JRPP No:	Item No. 2010STH022
DA No:	DA-2010/905
PROPOSED DEVELOPMENT:	15 Storey mixed use development
APPLICANT:	Cnr Harbour and Burelli Streets, Wollongong
REPORT BY:	PRD Architects

ASSESSMENT REPORT AND RECOMMENDATION

Street Frontage Treatment

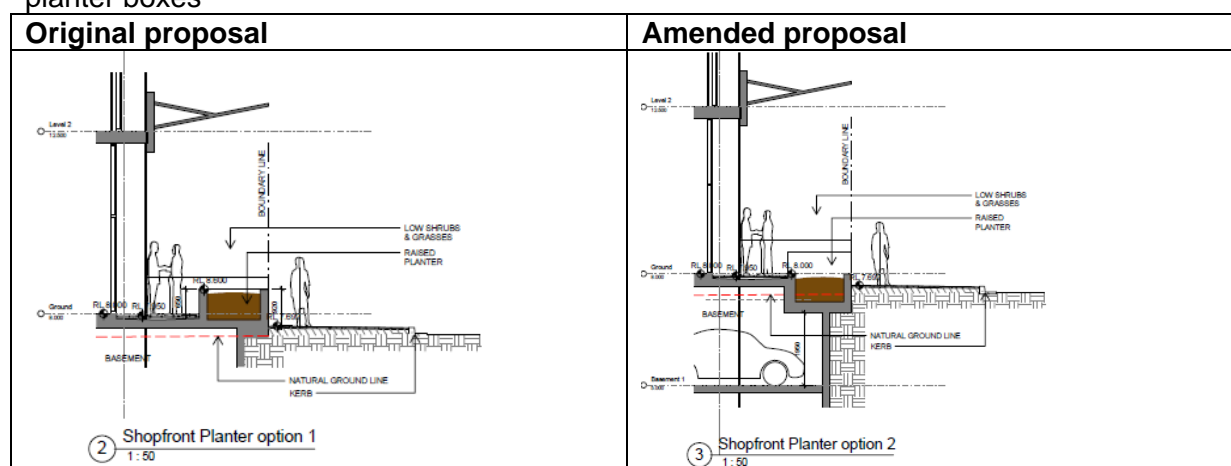
The unit layouts of the proposal are generally well considered, the aesthetics' of the building are also generally successful but would benefit from further refinement. The base of the building has the potential to relate well to the street with further detail development. It is recommended that a nil set back is allowed to the northern boundary at ground floor level to facilitate a continuous retail strip to address Harbour Street.

It is noted that there is a change in levels along the Harbour Street frontage and that the planter box were included for safety reasons. Whilst the design review panel considers the 650mm raised planter bed as a visual obstruction to the commercial/street interface it is considered that the level planter bed will not allow for sufficient safety. Additionally a planter bed being level with the commercial could encourage people to use the planter boxes as access and over time killing the landscaping within it. It is considered that a combination these two options could be conditioned by providing for a planter box that is 400mm high and allow for a physical barrier but not a visual barrier as the panel suggested. In this regard a condition is proposed (attachment 5) requiring amended plans allowing for a 400mm high planter box prior to the issue of a Construction Certificate.

Even though we believe that our treatment to the Harbour Street frontage is the appropriate one, we have provided an additional sectional diagram to illustrate another alternative treatment which could be pursued if Council deems it more appropriate. An alternative treatment could be a Condition of Consent. We provided the central planter for both aesthetic and safety reasons, due to the slope of the frontage. We do not believe that the planter should have any impact on the activation of the street frontage.

In terms of the Burelli Street frontage, we still believe that this street is contextually a secondary street which does not require any additional commercial or retail space. Our point is strengthened by the fact that the proposal for the large mixed use project on the Dwyers site, which is only 3 sites to our west incorporates parking access and predominantly service areas to the Burelli Street frontage.
